Generic Evaluation of Feedwater Transients and Small Break Loss-of-Coolant Accidents in Westinghouse-Designed Operating Plants

**Office of
Nuclear Reactor Regulation**

**U.S. Nuclear Regulatory
Commission**

**Bulletins and Orders Task Force
Office of Nuclear Reactor Regulation
U.S. Nuclear Regulatory Commission
Washington, D.C. 20555**

Auxiliary Feedwater System
 Surry Nuclear Station
 Figure 1

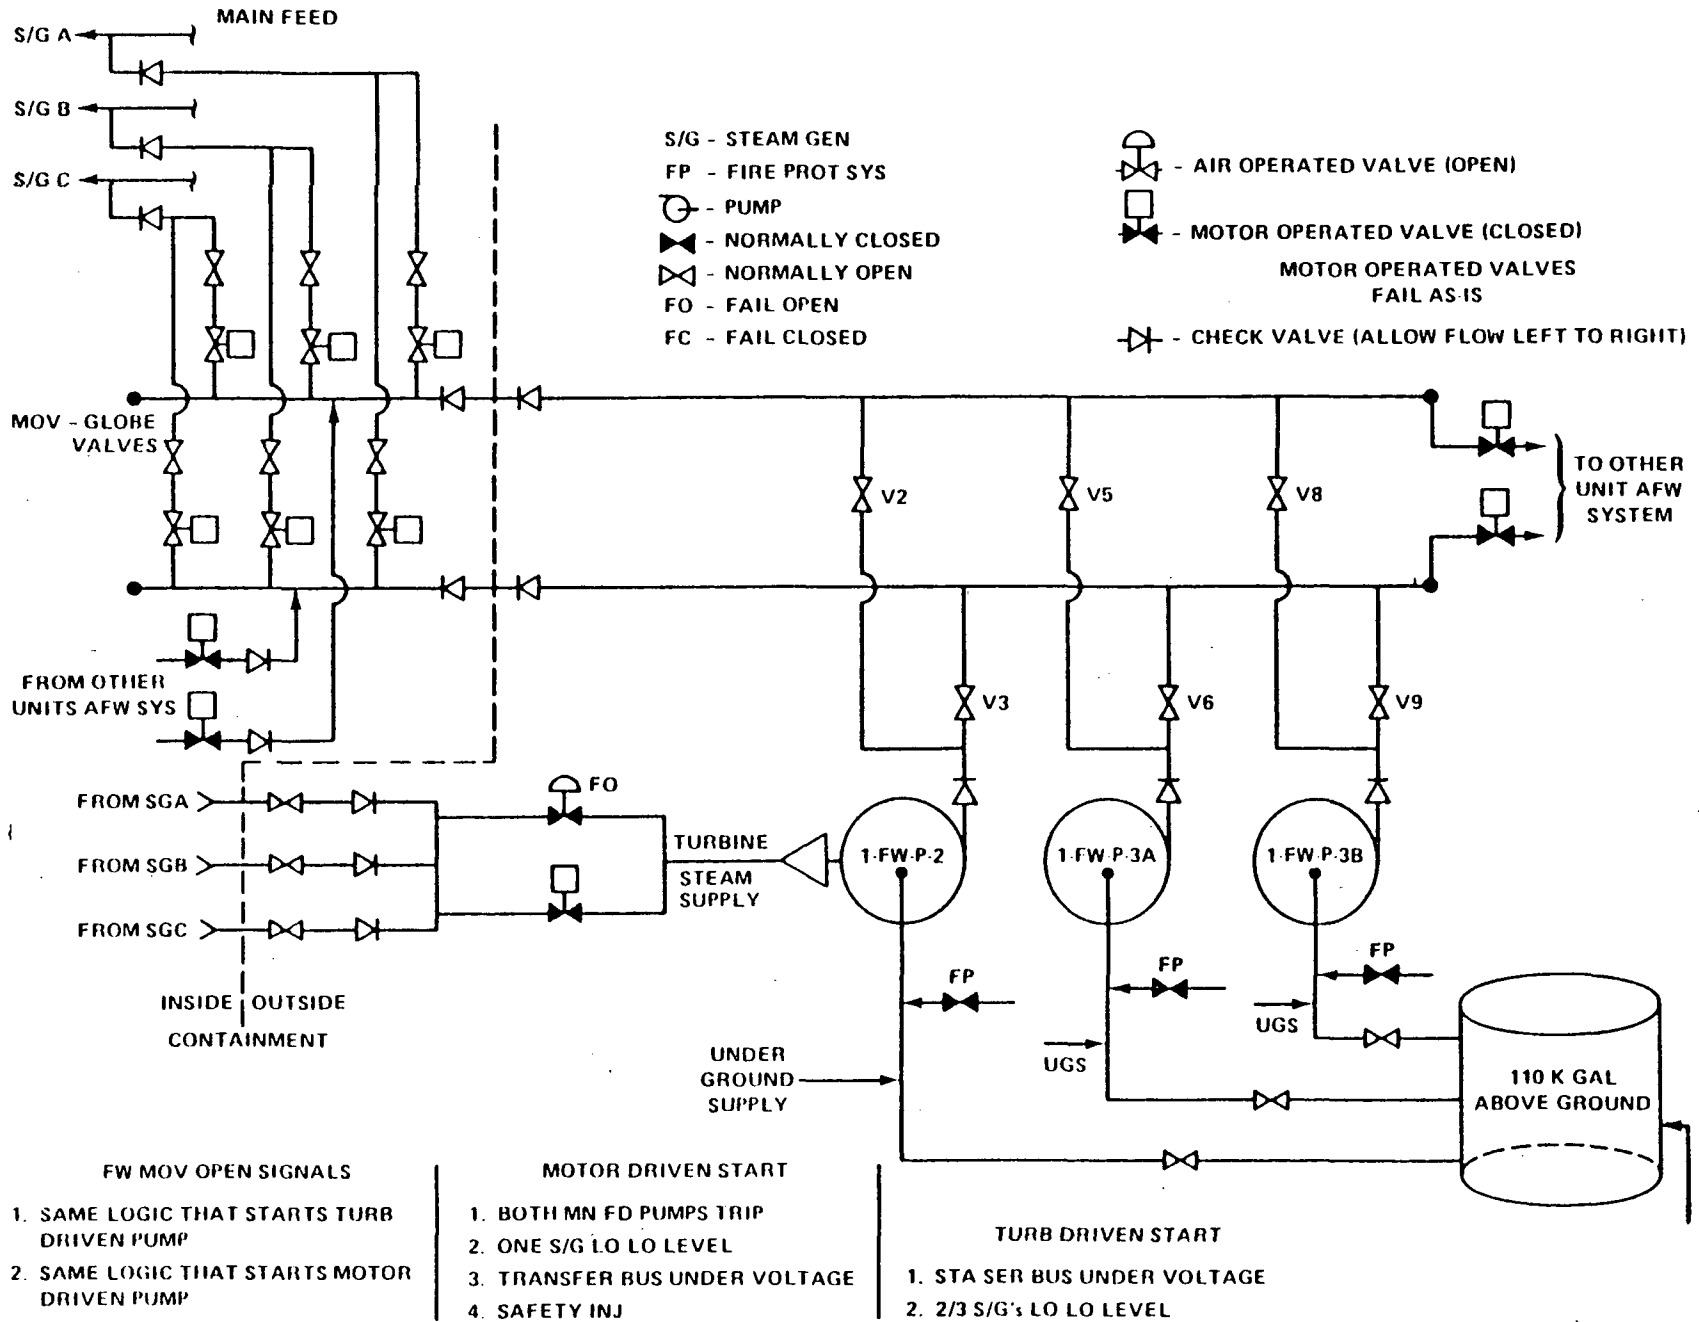
Long-term recommendations for improving the system are as follows:

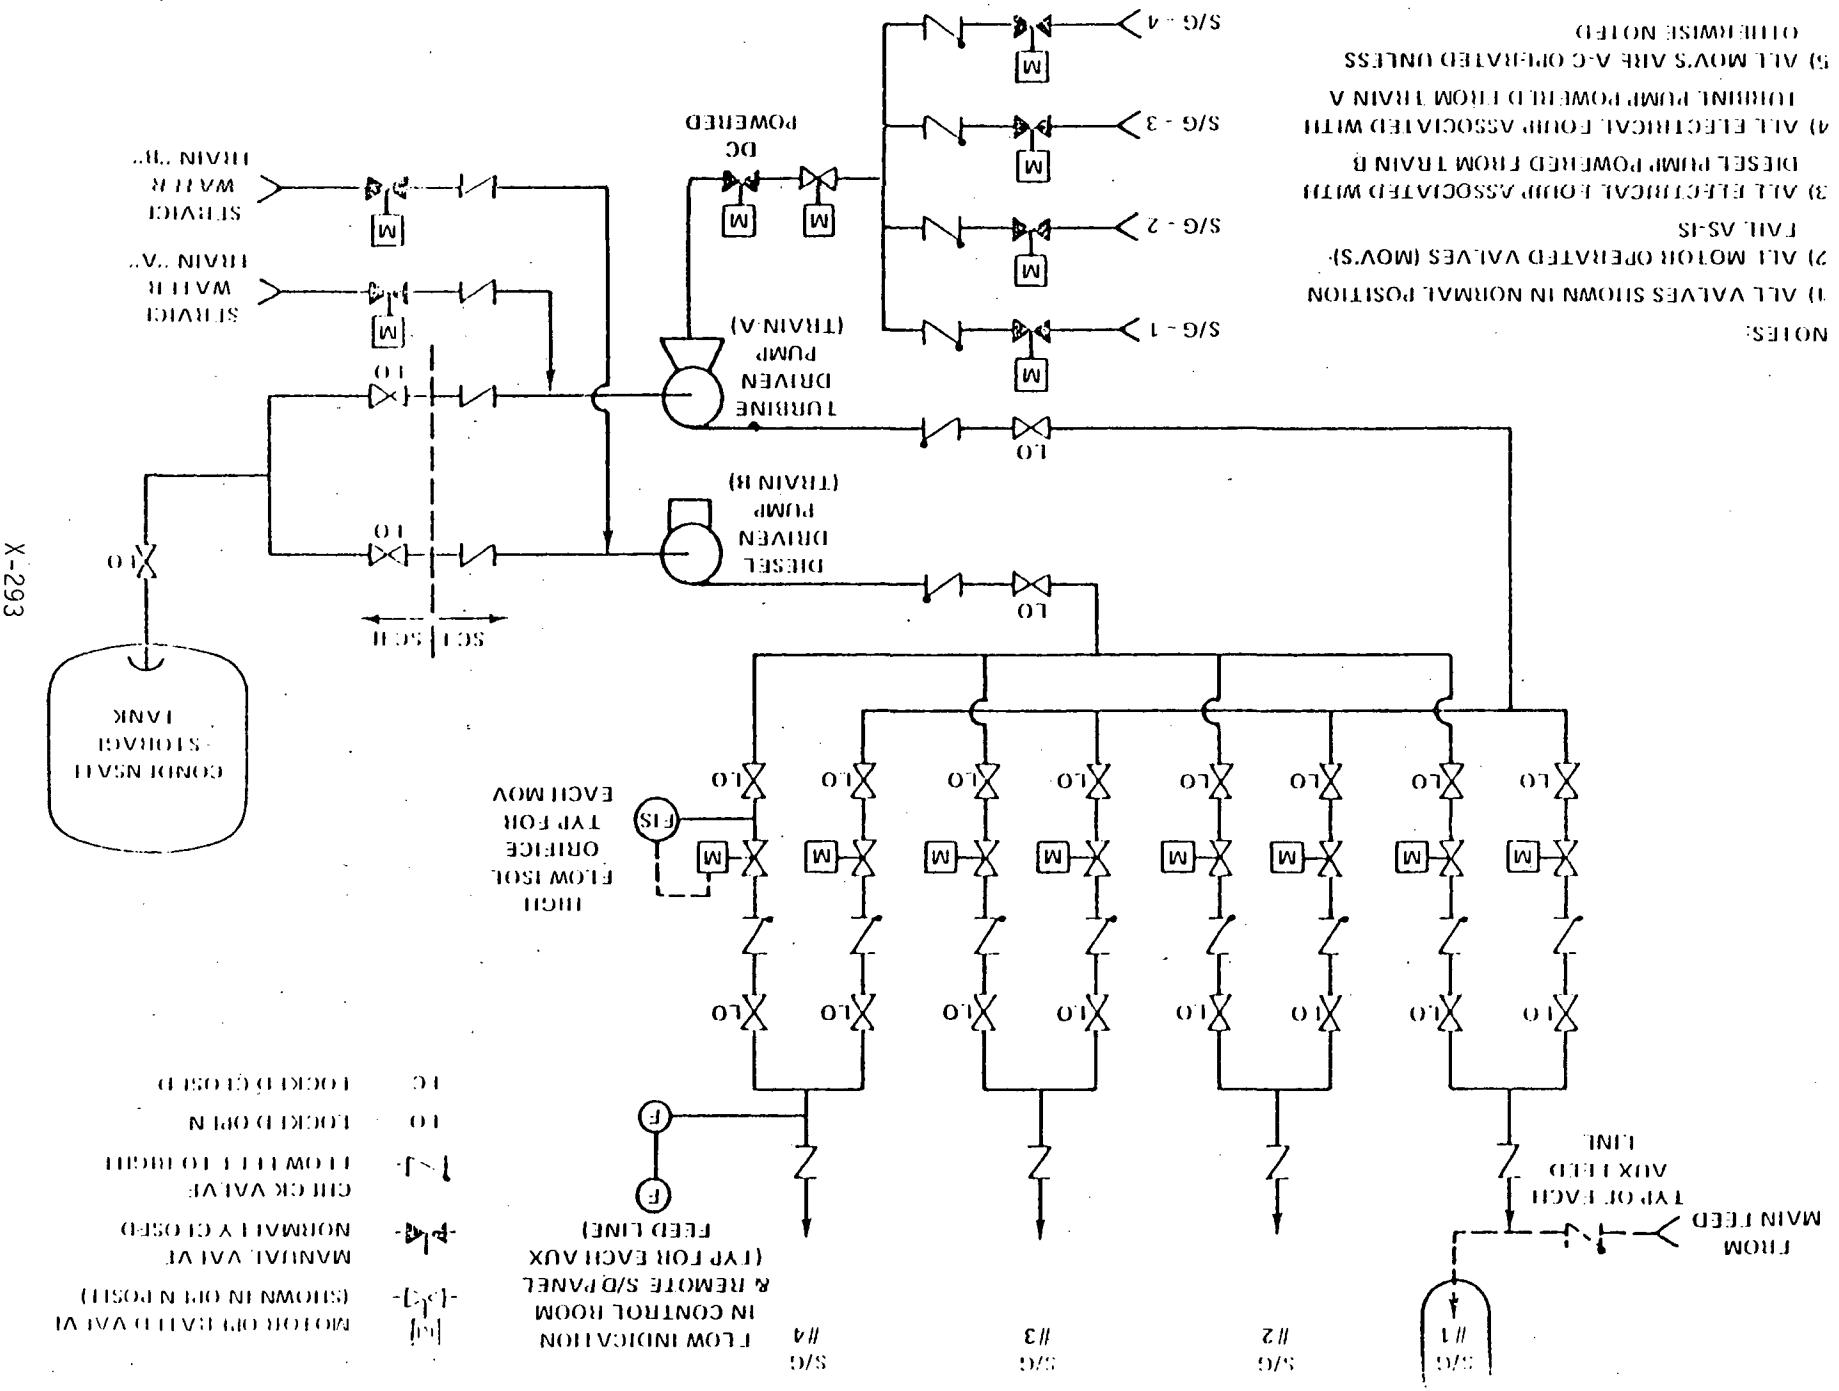
The licensee should propose Technical Specifications to incorporate appropriate periodic inspections to verify the valve positions.

2. Recommendation - GL-3 - At least one AFW system pump and its associated flow path and essential instrumentation should automatically initiate AFW system flow and be capable of being operated independently of any alternating current power source for at least two hours. Conversion of direct current power to alternating current is acceptable.
3. Recommendation - GL-4 - Licensees having plants with unprotected normal AFW system water supplies should evaluate the design of

Auxiliary Feedwater System
 Turkey Point (Units 3 and 4)
 Figure 1

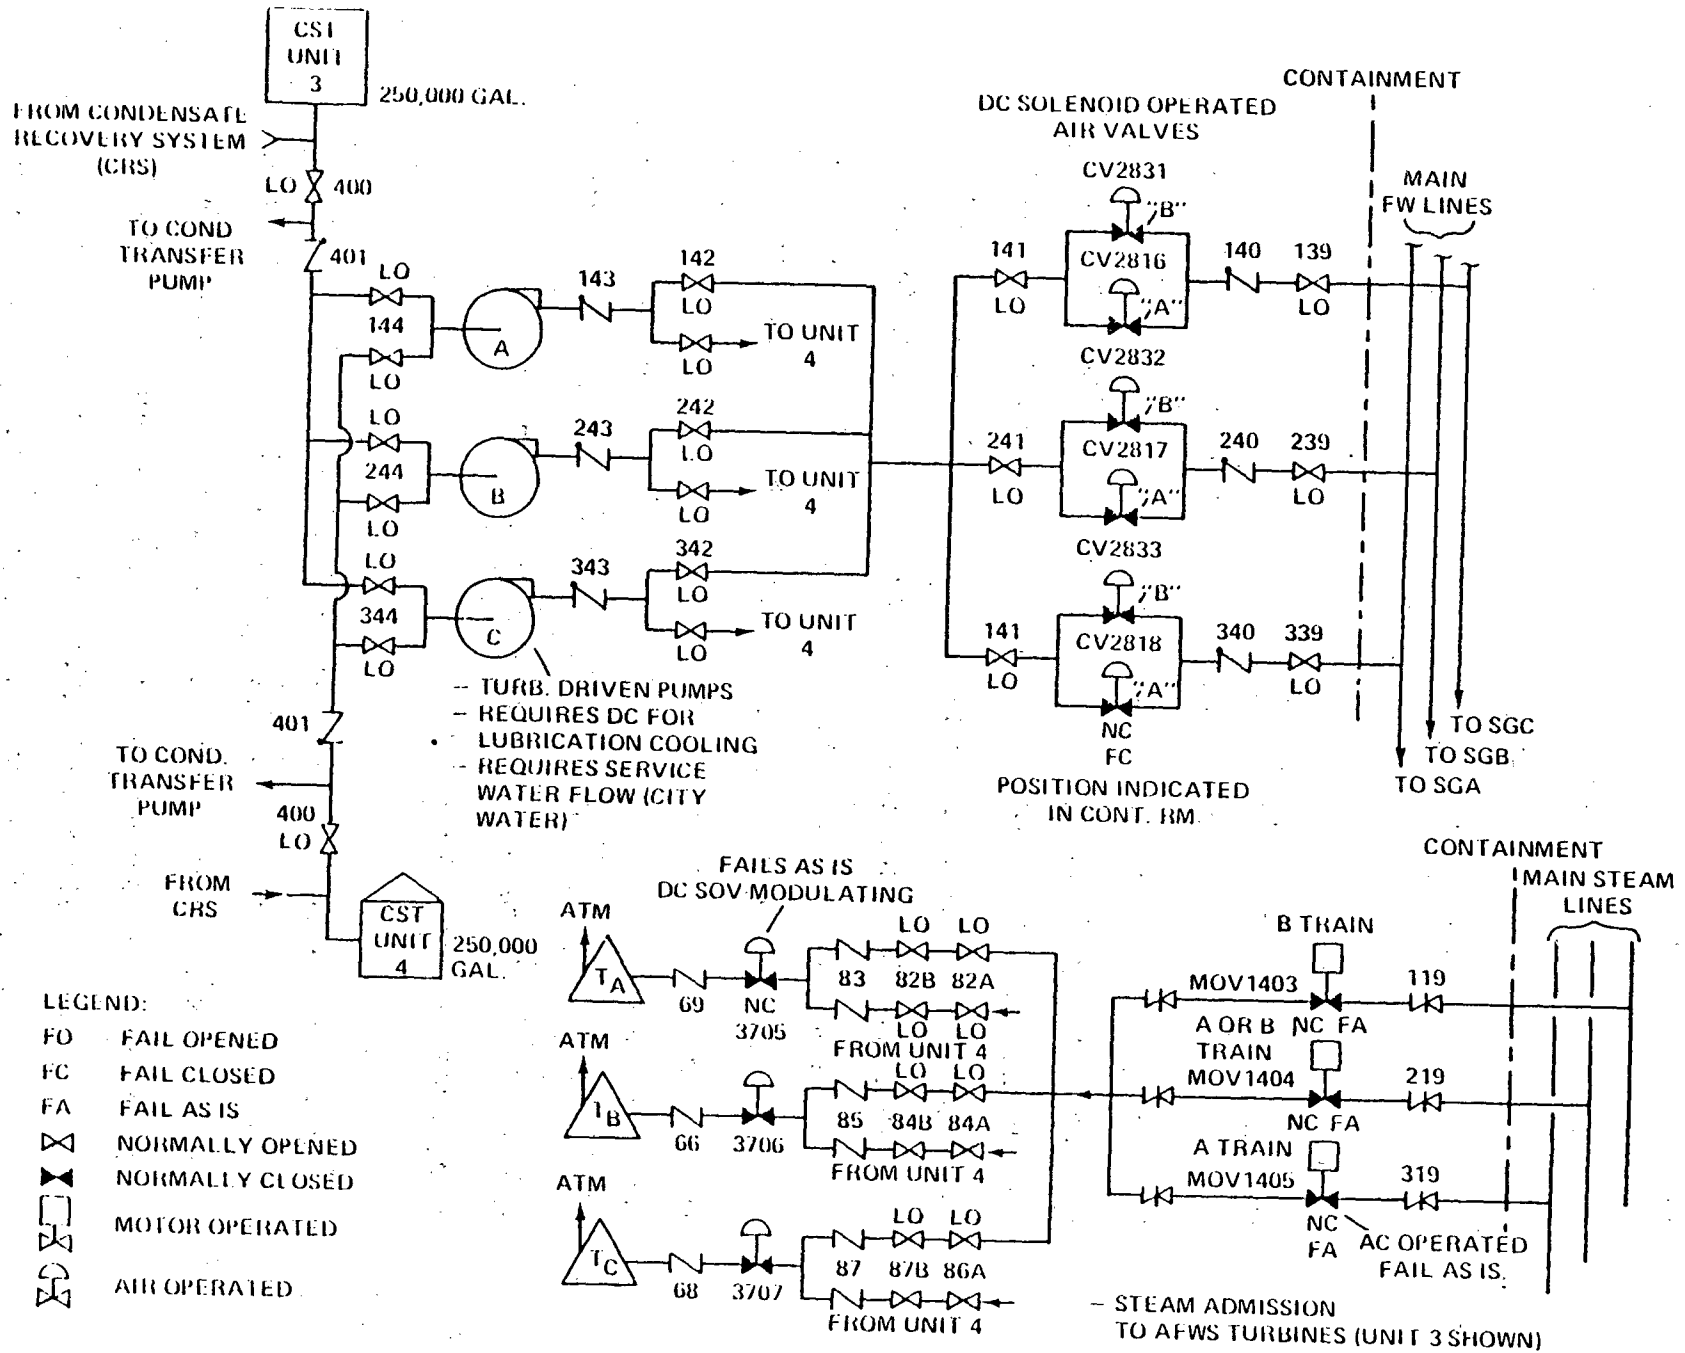
Long-term recommendations for improving the system are as follows:

Auxiliary Feedwater System
Yankee Rowe
Figure 1

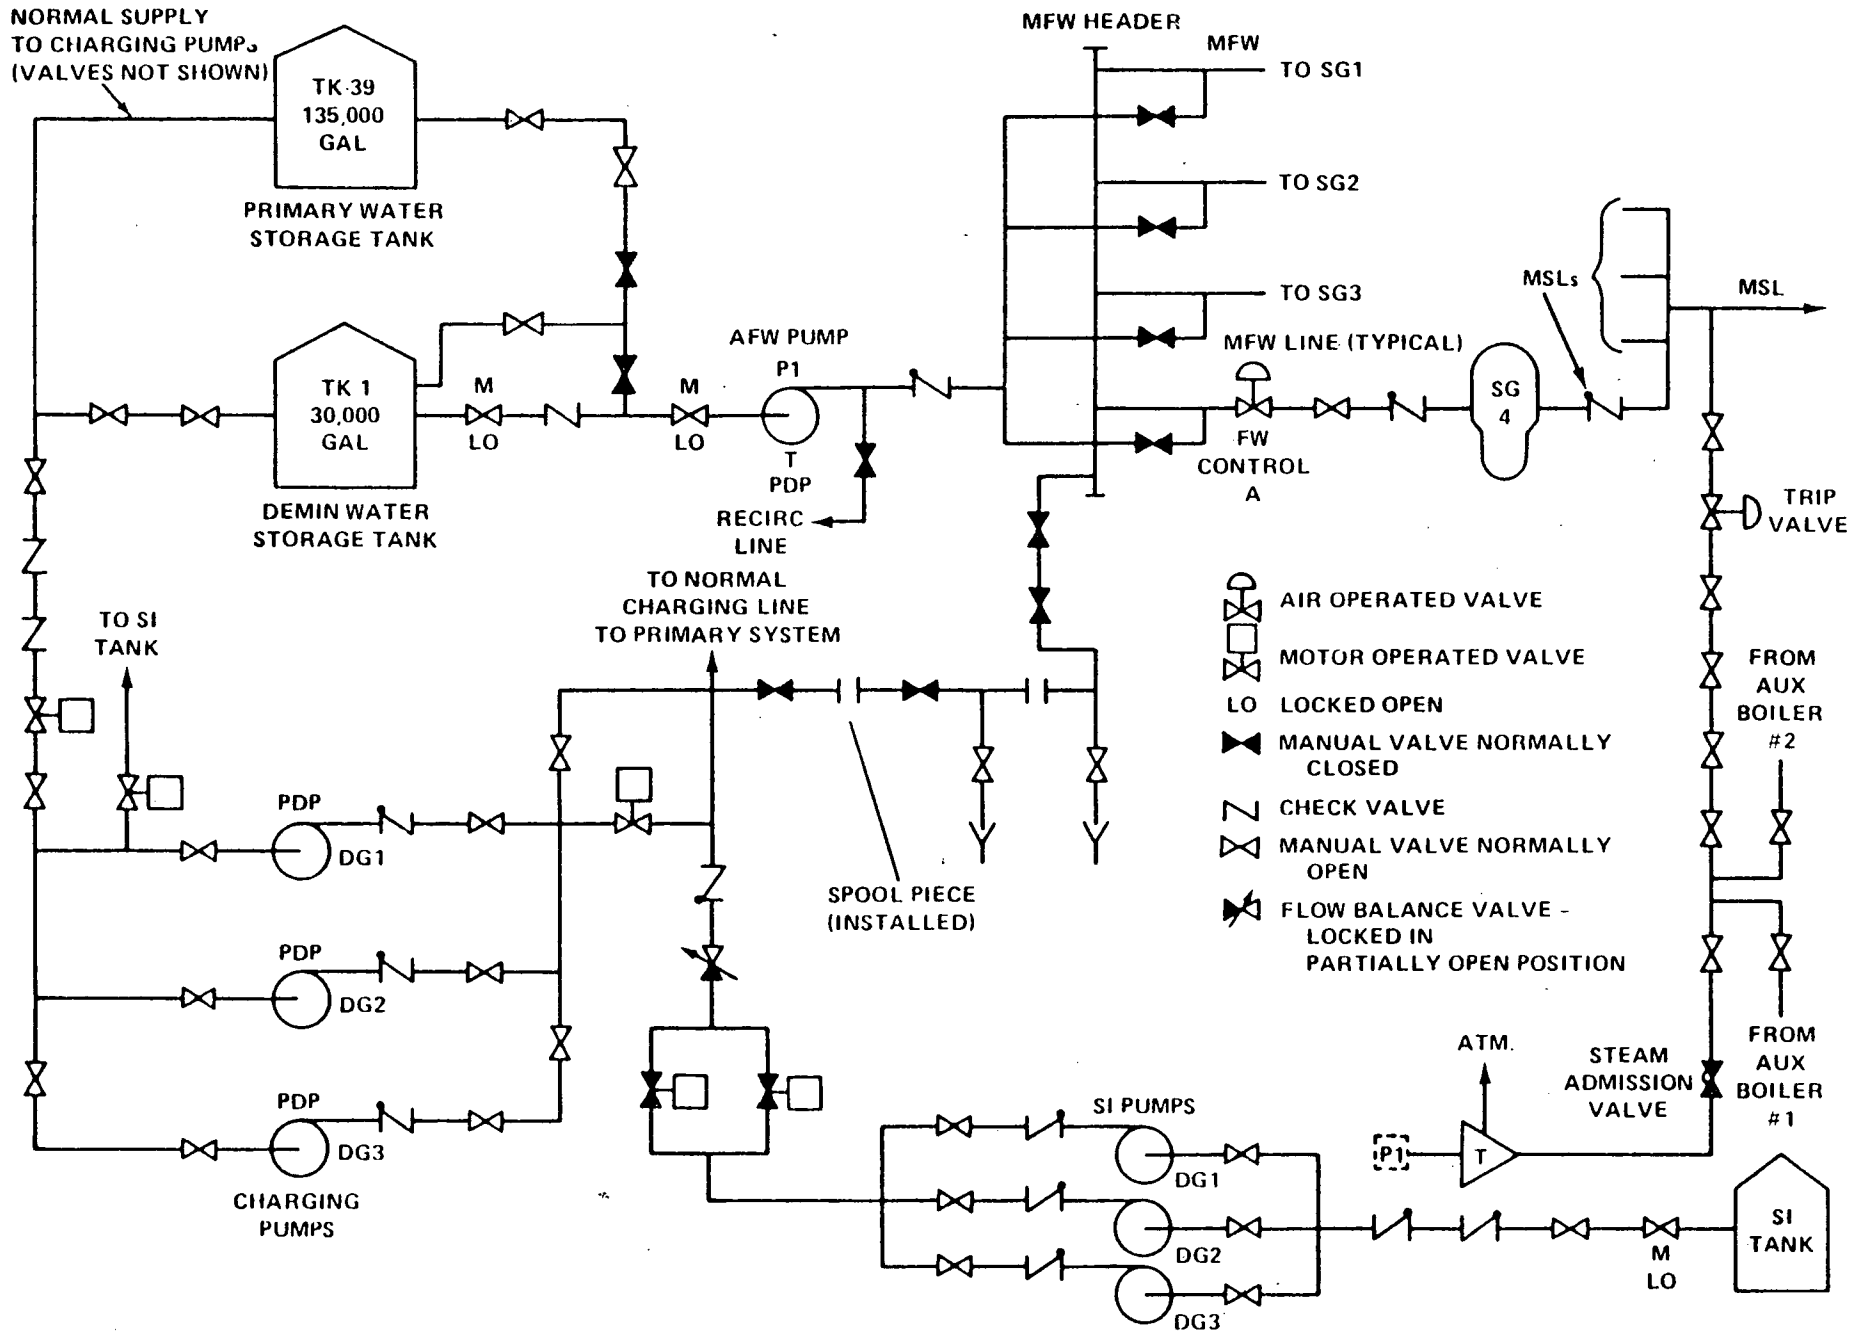
3. Recommendation - A pipe break in the Main Feedwater header upstream of the control valves could cause loss of all AFW flow to all steam generators since the AFW pump and the charging/SI pumps connect to this header. The licensee should evaluate the consequences of a pipe break in this section of the MFW header and 1) determine any system design changes or emergency procedures necessary to detect and isolate the break and direct the required AFW flow to the steam generators before they boil dry or 2) describe how the plant can be brought to a safe shutdown condition by use of other available systems following such a postulated event.

4. Recommendation - The air operated trip valve in the auxiliary steam header which supplies steam to the turbine driven AFW pump closes upon receipt of a containment isolation signal. The
